### FINAL DRAINAGE REPORT FOR SADDLEHORN RANCH – FILING 2

> June 4, 2021 Project No. 25142.04

El Paso County PCD File No.: SF-21-033

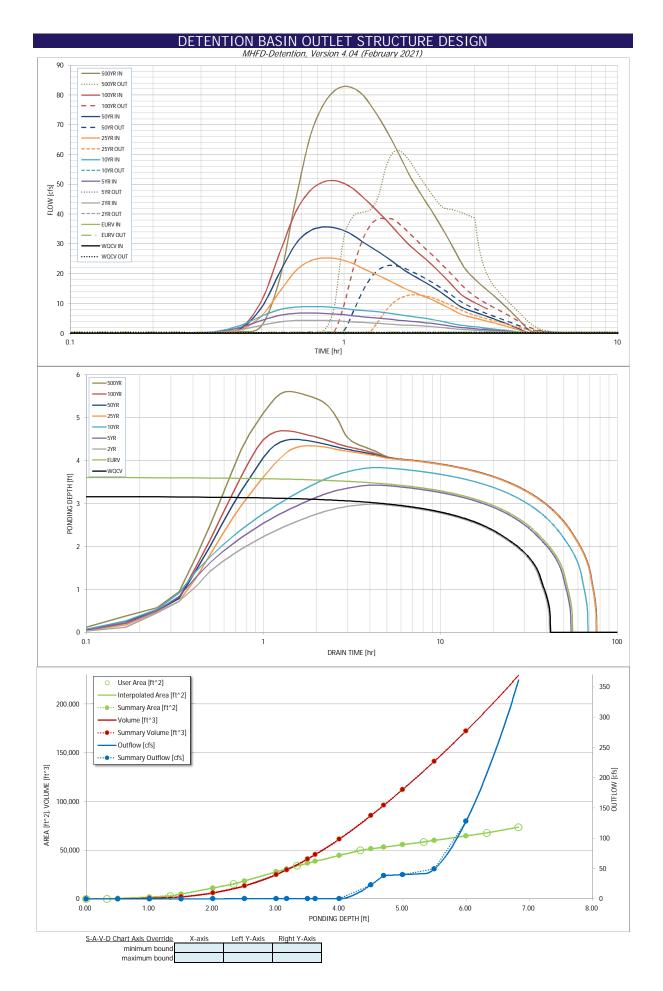
Provide design calculations for riprap spreader at pond outlet culvert

Unresolved-No design point 45 on plan. Add calcs for all culvert & pipe locations.

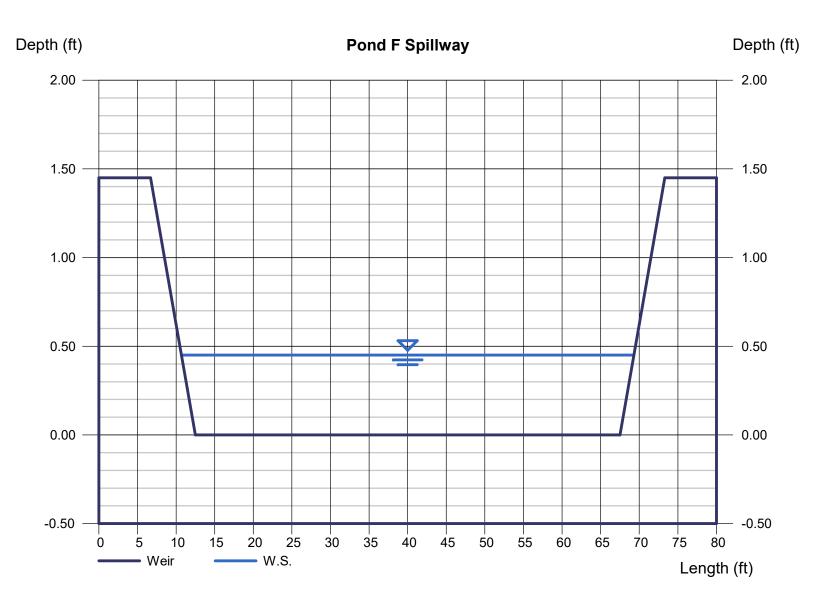
Review 2:

Unresolved - See Figure 13-12c in City of Colorado Springs DCM
